# Anderson Hall Renovation

University of Washington | DON Project Briefing

# AGENDA

Existing Mezzanine and Stairs

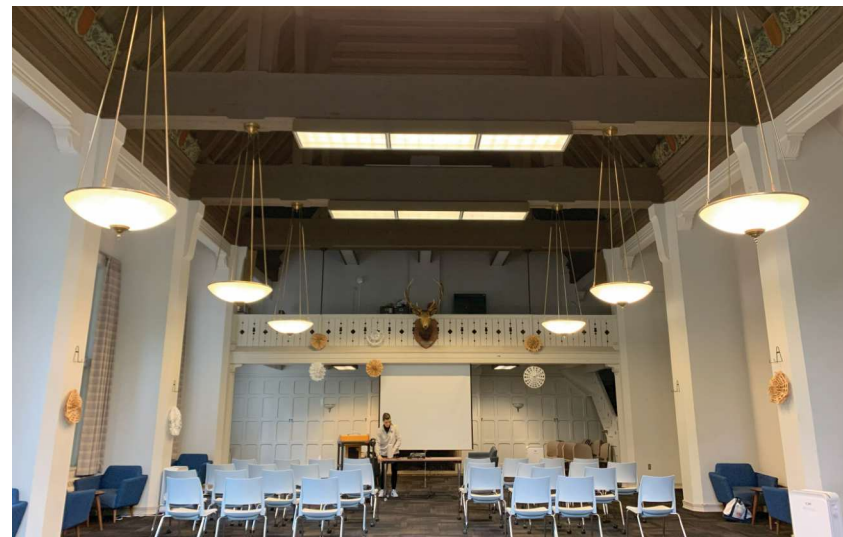
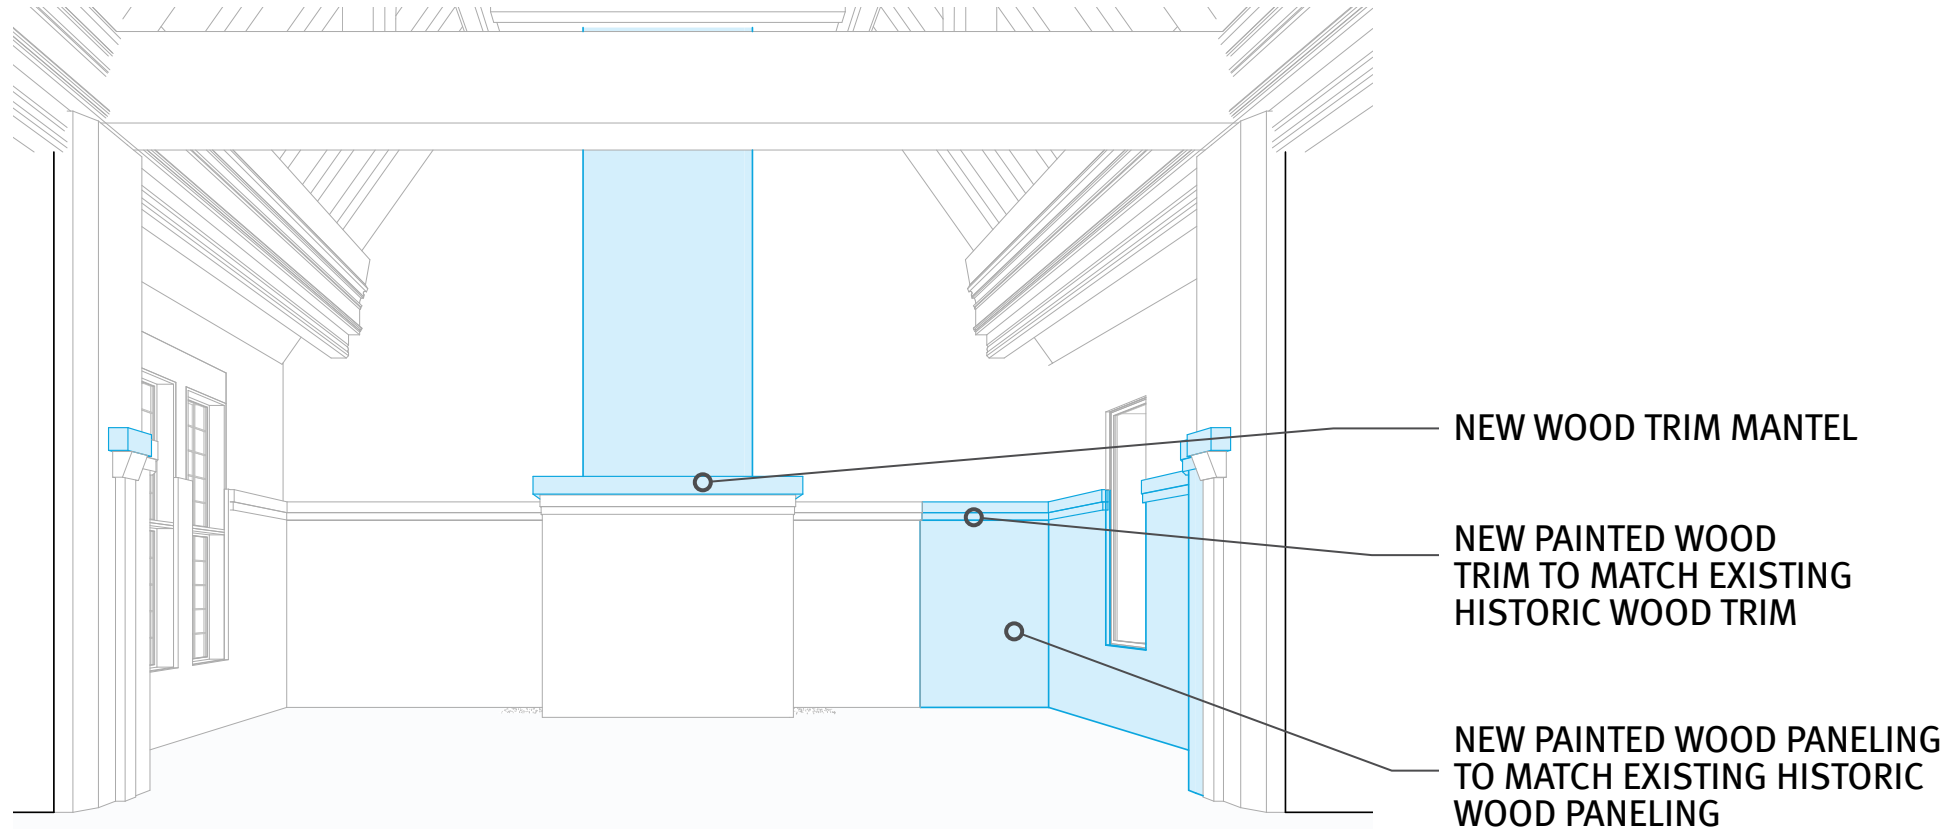
## SDCI FEEDBACK:

- Mezzanine does not comply with means of egress
- Mezzanine does not comply with stair and elevated surface guardrail heights
- SDCI requires restricting use of the mezzanine with a more robust barrier than the existing chain and signage

## MODIFICATIONS REQUIRED FOR COMPLIANCE & USE:

- Supplement existing structural members to account for occupant load and required guardrail modifications
- Enlarge footprint of mezzanine stair
